ADDENDUM

JLG 16098 Bottineau Ridge II Apts

Issued: December 07, 2017

ADDENDUM #: 01

FIRST FLOOR FRAMING PLAN - WEST

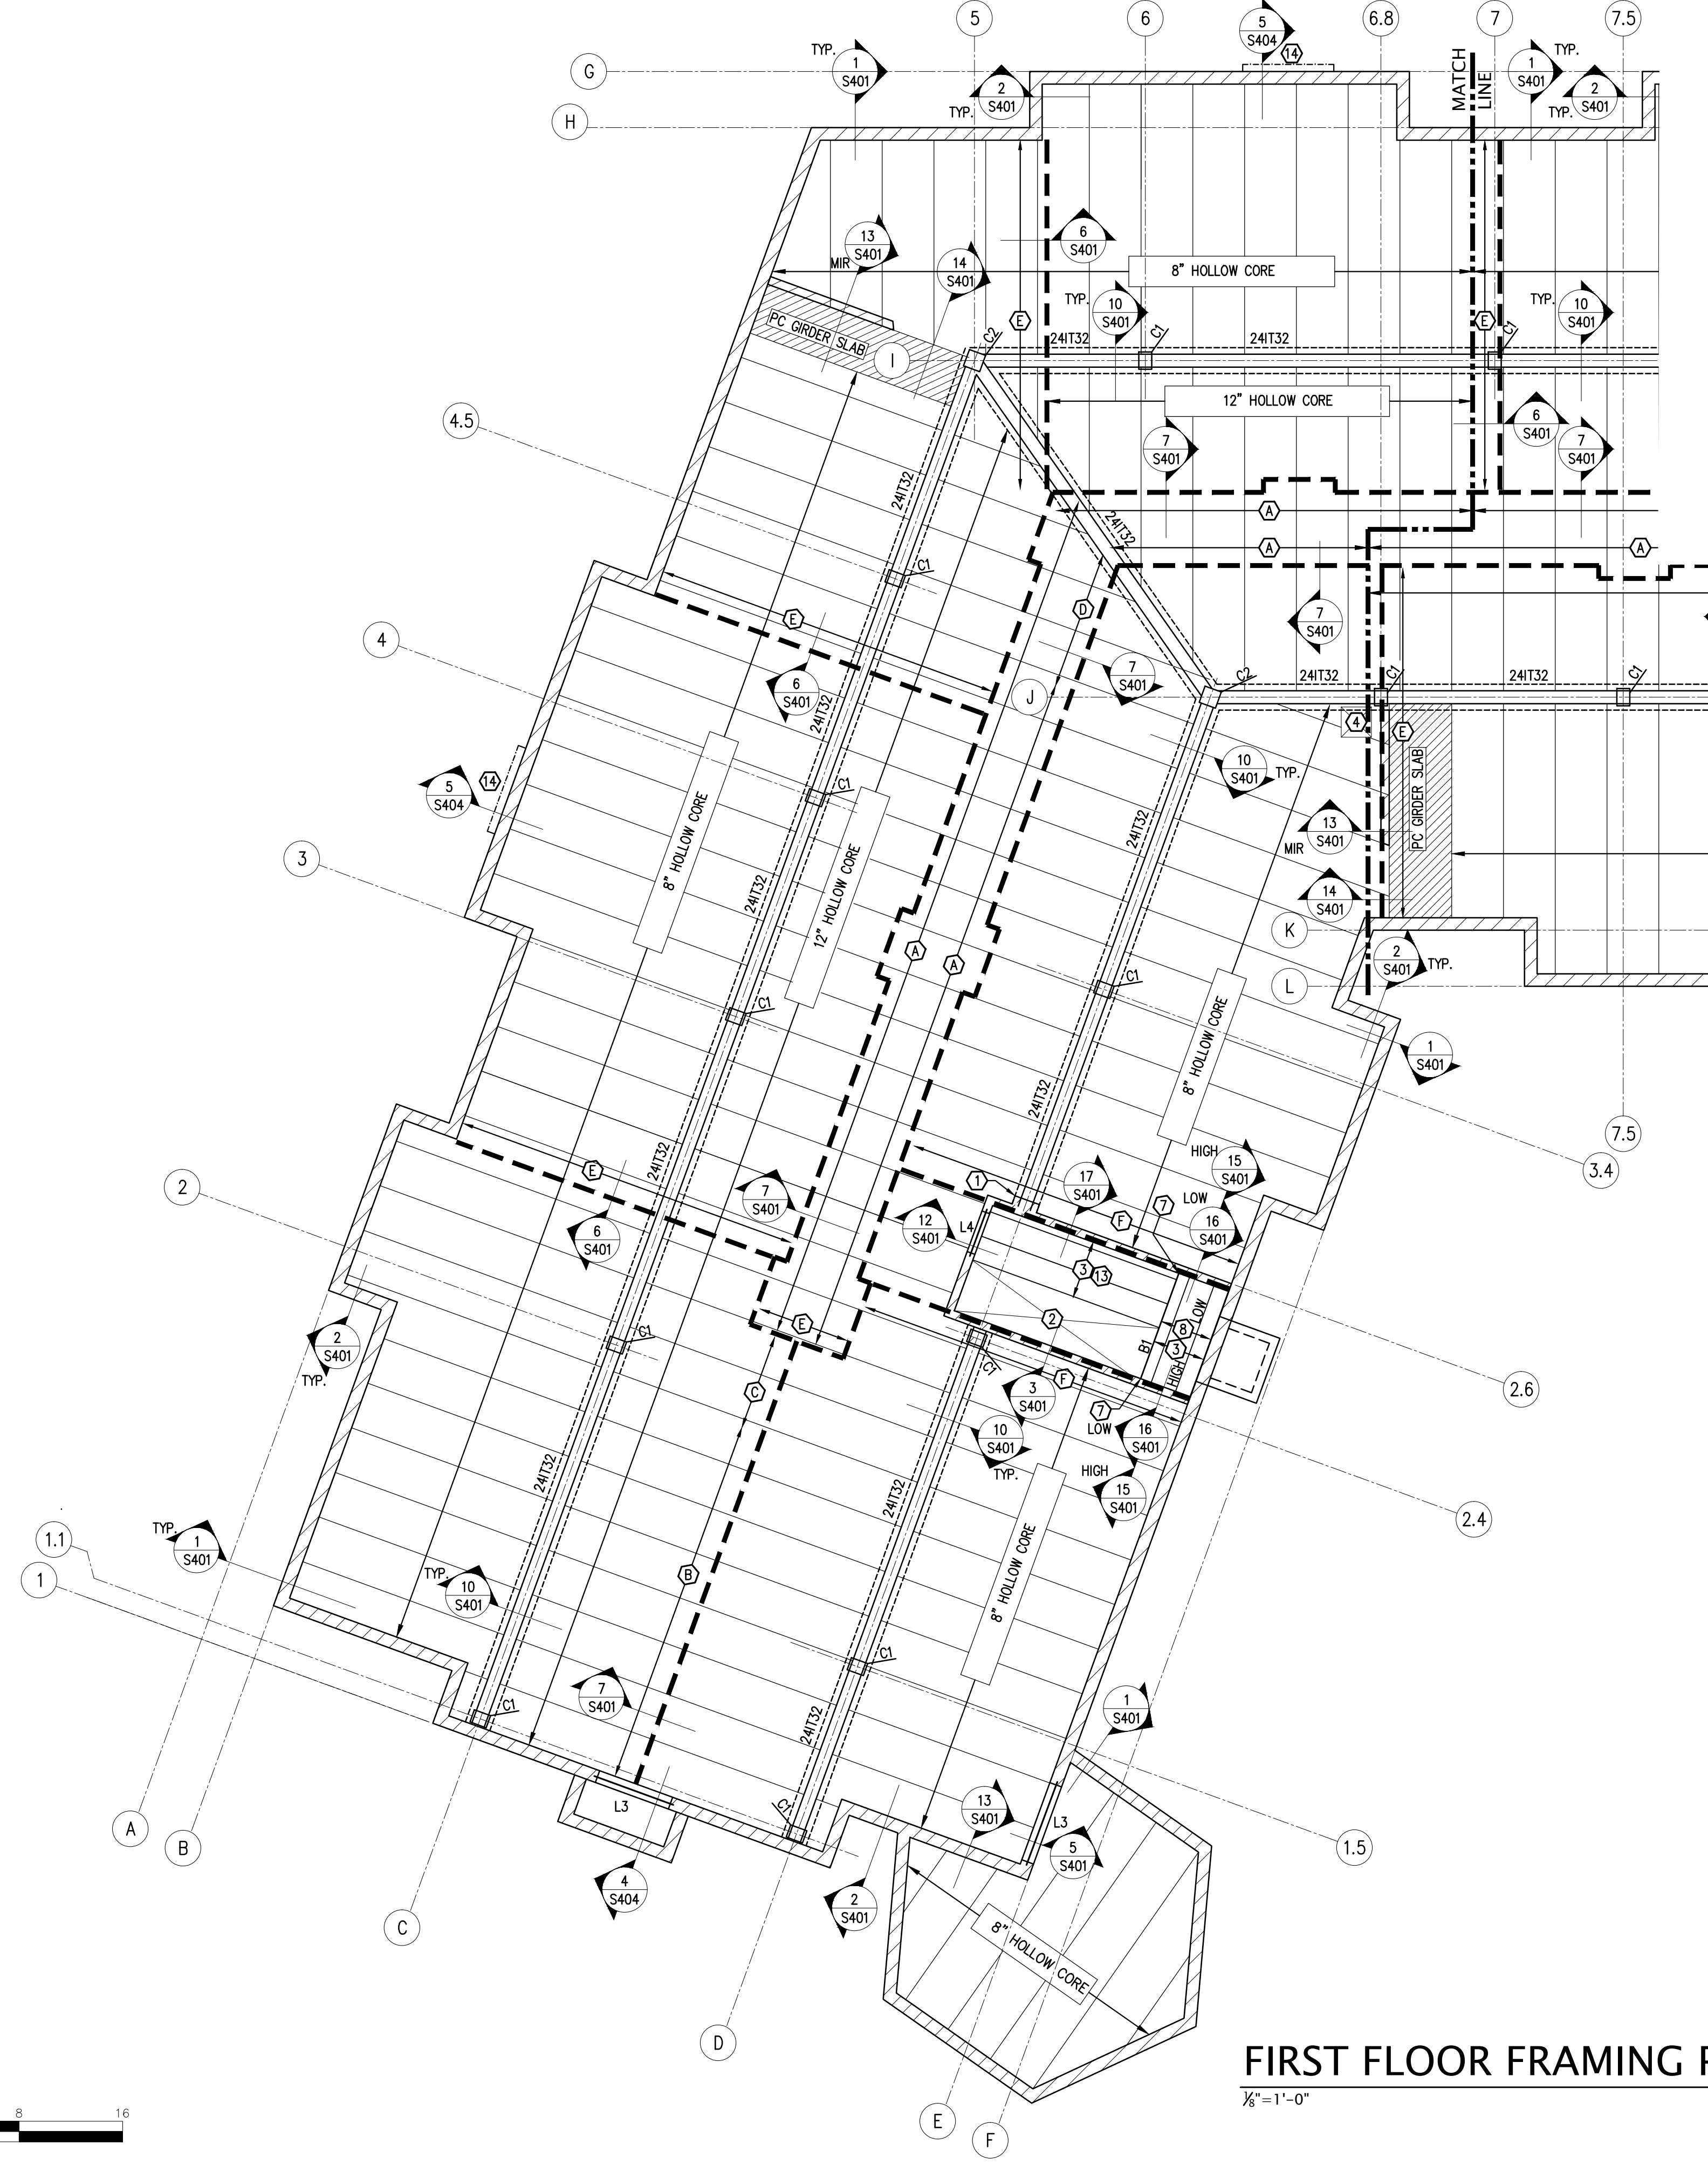
6. S201A FIRST FLOOR FRAMING PLAN "WEST". See Sheet S201A
 - o Plan notes were revised to include the reinforcing requirements for the cast in place foundation walls.

- TYPICAL REINFORCEMENT OF LOWER LEVEL TO BE:
 12" CMU - EXTERIOR WALLS, U.N.O.:
 #6 VERTS @ 1'-4" O.C. (INSIDE FACE)
 12" CMU - INTERIOR WALLS:
 #5 VERTS @ 2'-8" O.C. (CENTERED)
 8" CMU INTERIOR/EXT. BRG. WALLS:
 #5 VERTS @ 2'-8" O.C. (CENTERED)
 SEE GENERAL NOTES ON S001, 10/S301, AND PLAN FOR ADDITIONAL REINFORCEMENT REQUIRED.
- PRECAST SUPPLIER TO PROVIDE FRAMED FLOOR OPENING FOR ELECTRICAL FEED LINES. G.C. TO COORDINATE WITH ELECTRICAL.
- PRECAST TOPPING TO BE 1" GYPCRETE. TOPPING TO BE NON-COMPOSITE FOR PRECAST DESIGN.
- SEE SHEET S206/S207 FOR SHEAR WALL COMPONENTS EMBEDDED INTO CMU FOUNDATION WALLS.

FIRST FLOOR FRAMING PLAN - EAST
 1/8" = 1'-0" T.O. H.C. PLANK = 99'-11" U.N.O.

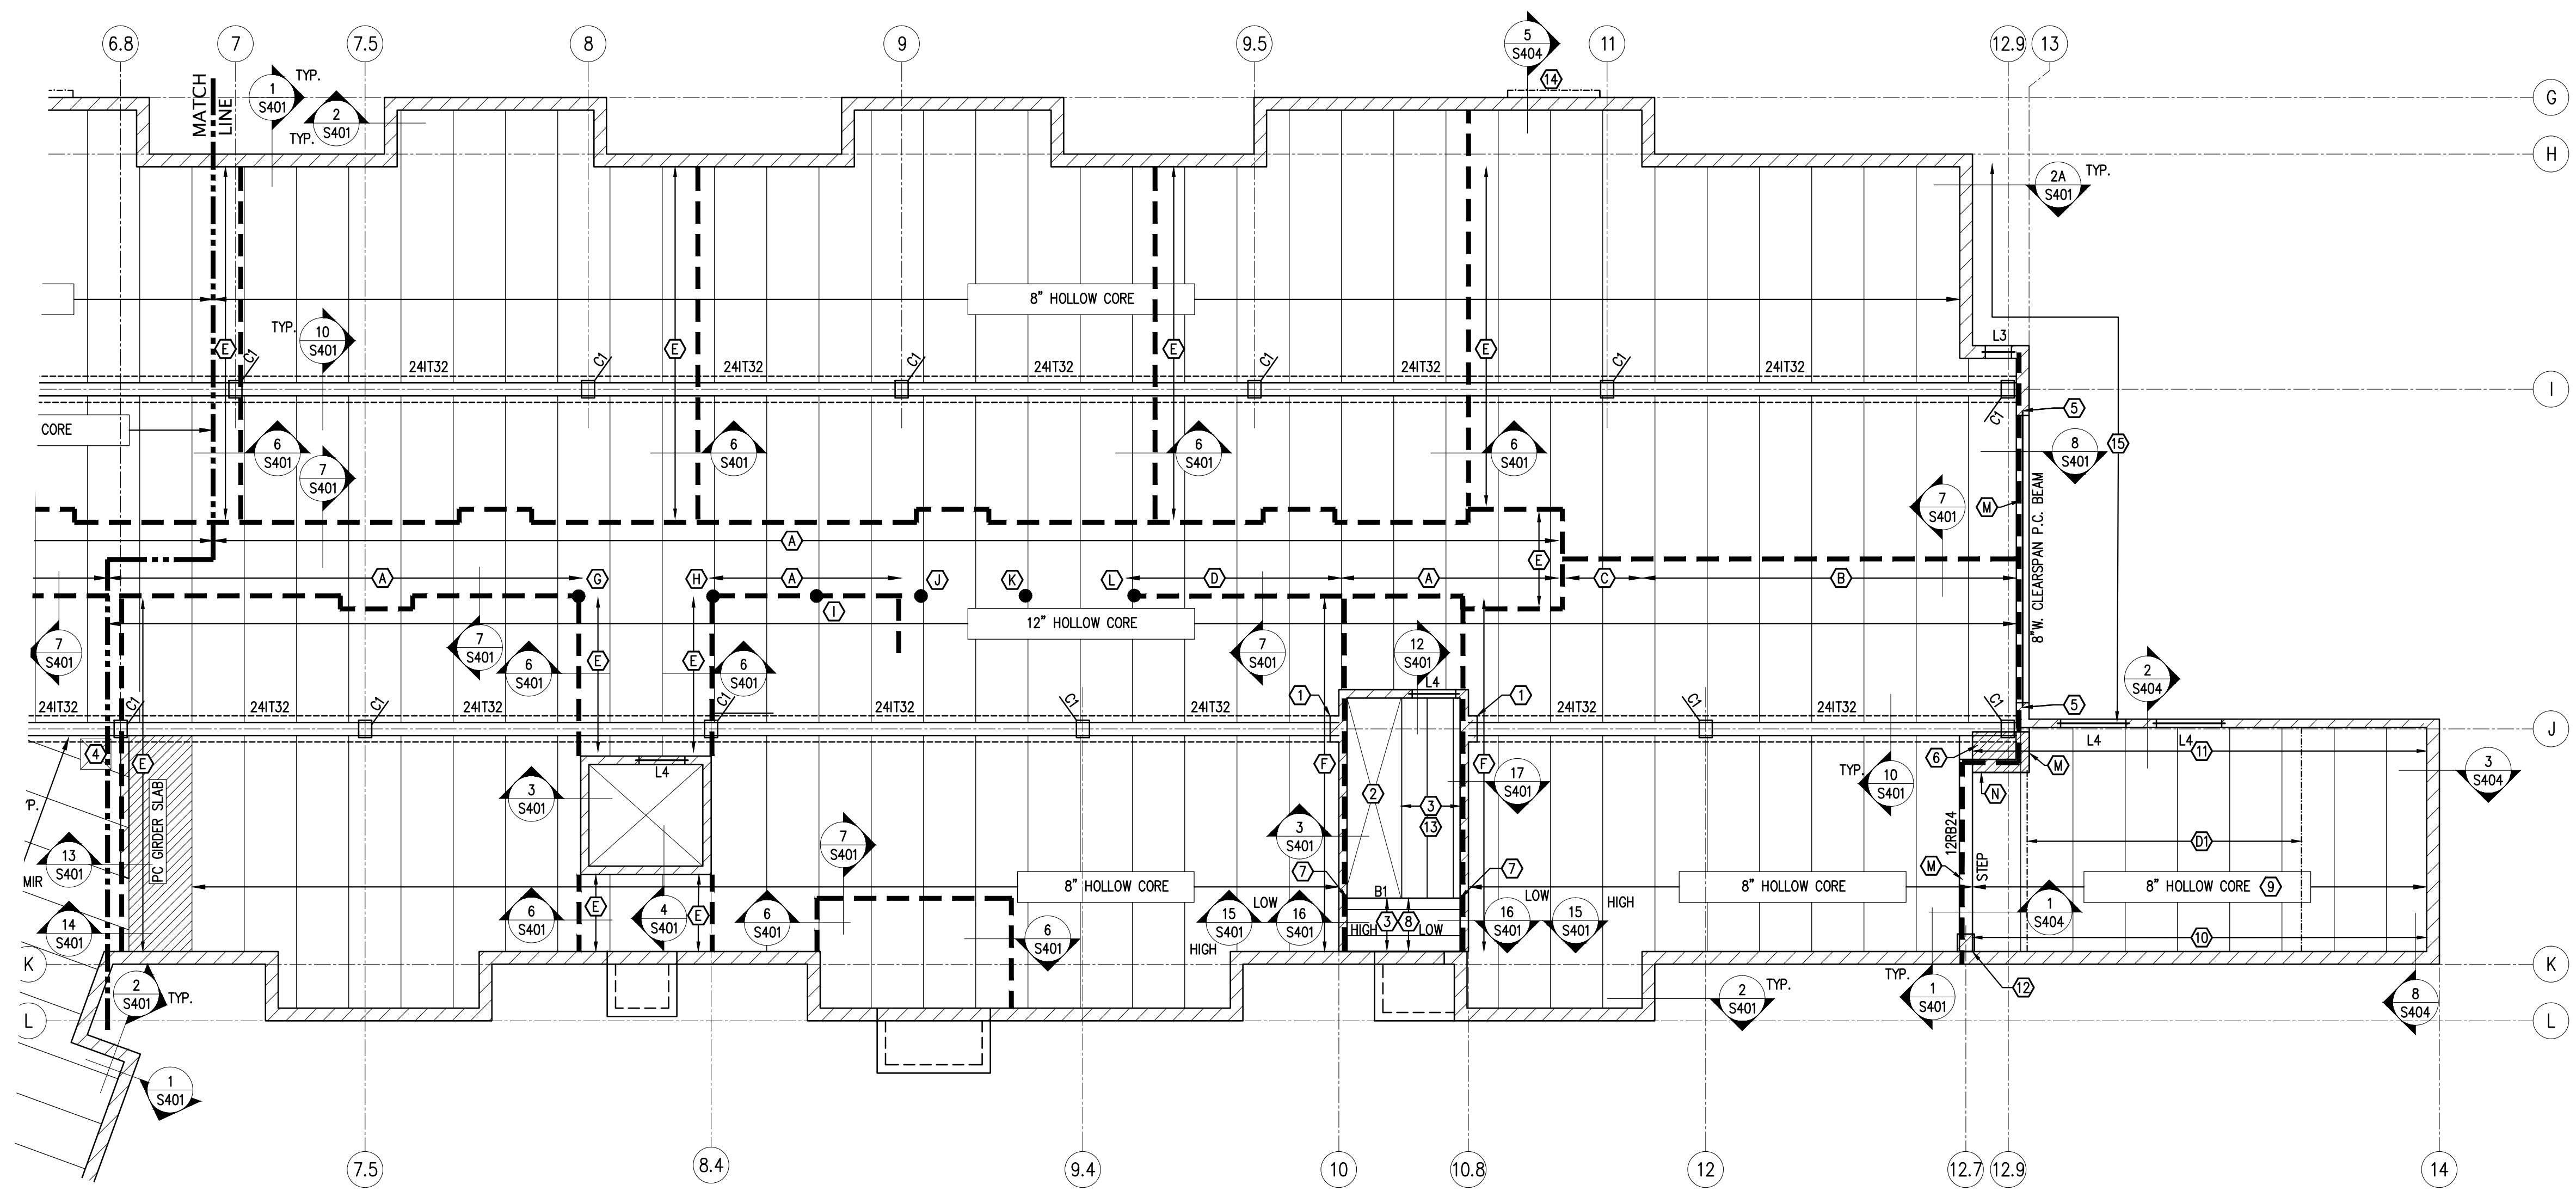
7. S201B FIRST FLOOR FRAMING PLAN "EAST". See Sheet S201B
 - o Plan notes were revised to include the reinforcing requirements for the cast in place foundation walls.

- PRECAST & CMU PLAN NOTES:**
- TYPICAL REINFORCEMENT OF LOWER LEVEL TO BE:
 12" CMU - EXTERIOR WALLS, U.N.O.: #6 VERTS @ 1'-4" O.C. (INSIDE FACE)
 12" CMU - INTERIOR WALLS: #5 VERTS @ 2'-8" O.C. (CENTERED)
 8" CMU INTERIOR/EXT. BRG. WALLS: #5 VERTS @ 2'-8" O.C. (CENTERED)
 SEE GENERAL NOTES ON S001, 10/S301, AND PLAN FOR ADDITIONAL REINFORCEMENT REQUIRED.
 - PRECAST SUPPLIER TO PROVIDE FRAMED FLOOR OPENING FOR ELECTRICAL FEED LINES. G.C. TO COORDINATE WITH ELECTRICAL.
 - PRECAST TOPPING TO BE 1" GYPCRETE. TOPPING TO BE NON-COMPOSITE FOR PRECAST DESIGN.
 - SEE SHEET S206/S207 FOR SHEAR WALL COMPONENTS EMBEDDED INTO CMU FOUNDATION WALLS.

1 GARAGE FLOOR PLAN - WEST
A210A SCALE: 1/8" = 1'-0"

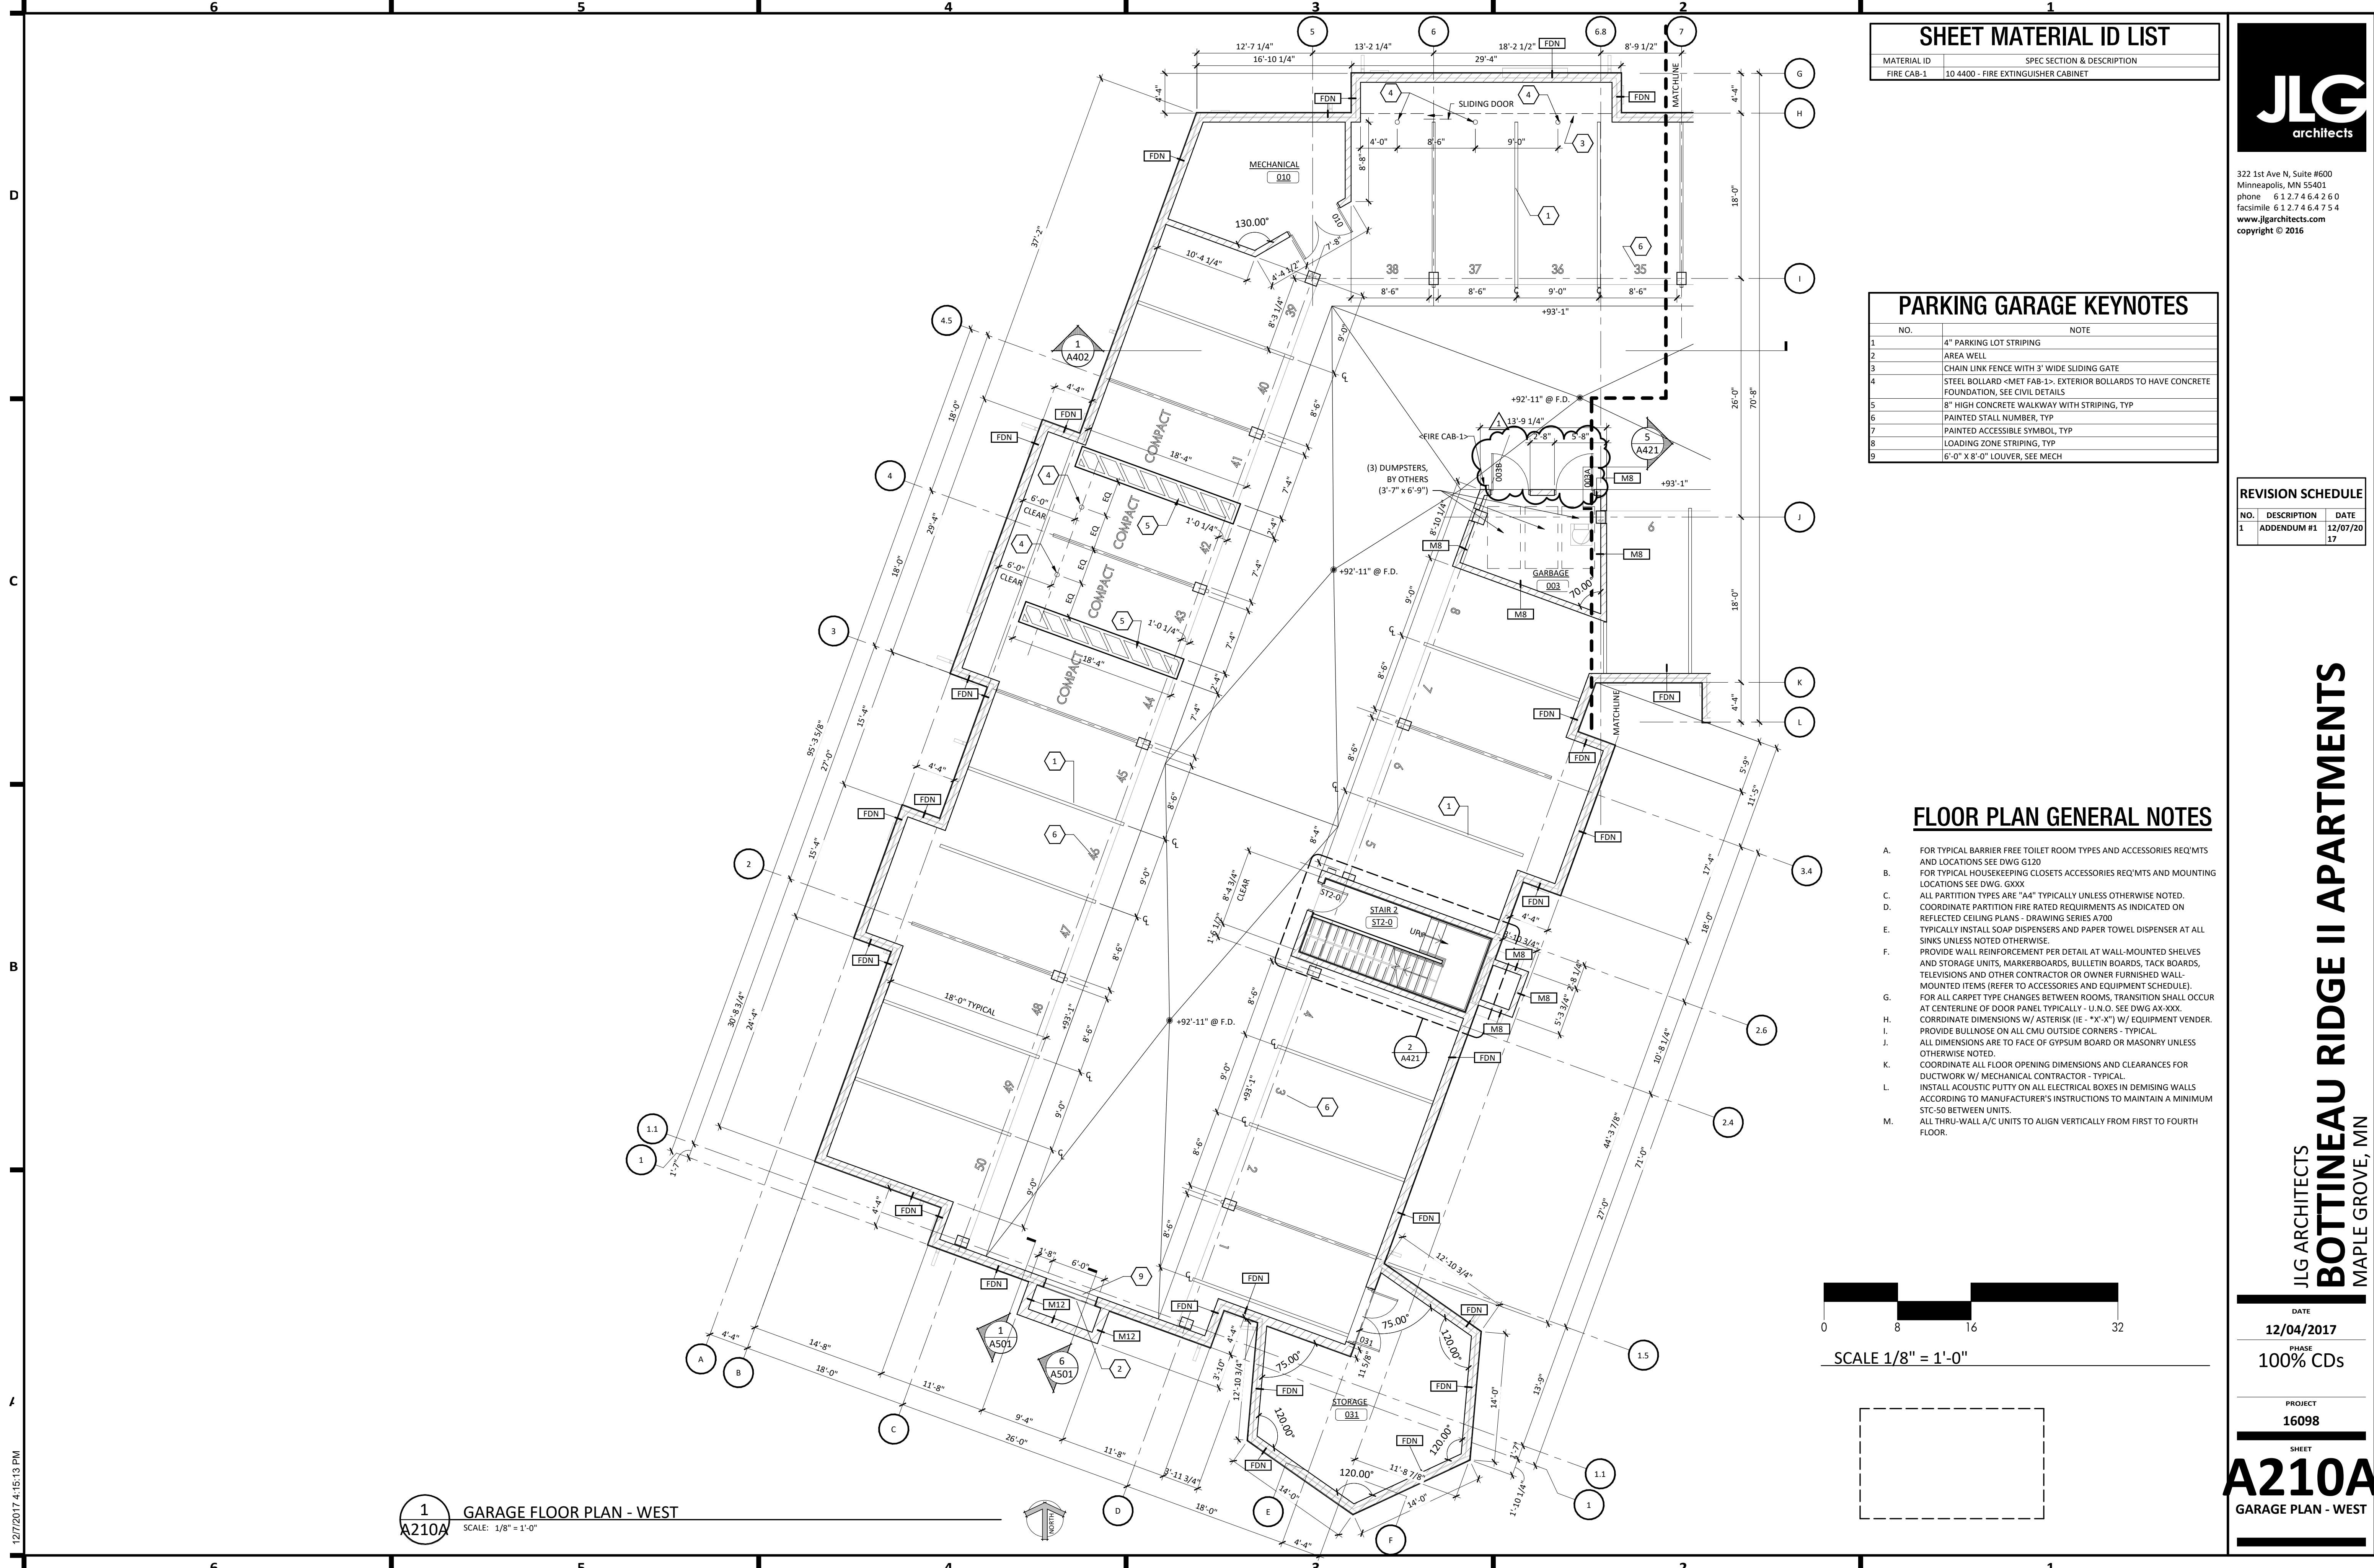
8. A210A GARAGE PLAN - WEST. See Sheet A210A.
 - o Detail 1/A210A. Added Door Tag "003B. Move Doors 003A and 003B.
9. A250 DOOR SCHEDULE & GLAZING ELEVATIONS. See Sheet A250.

DOOR TYPES

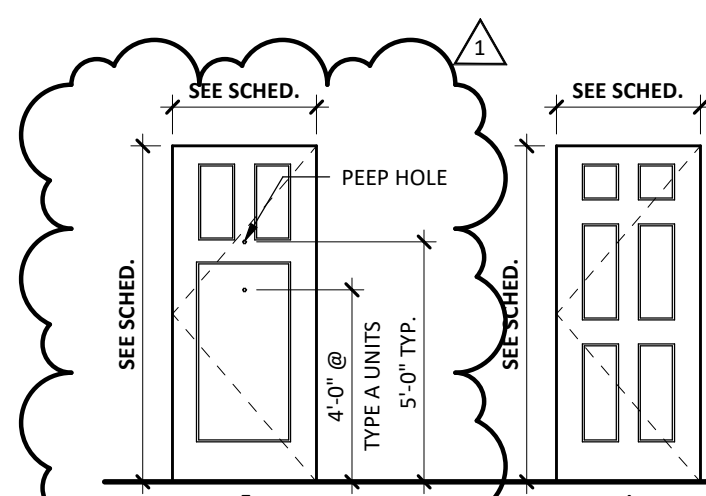
- Storefront Frame Types. Frame Type SF03 add note "@ Lobby-102B Glazing is <TEMP GL-1>".
- Door Types. Revised Door Type "E". Added applied trim to the Hallway side of the door.
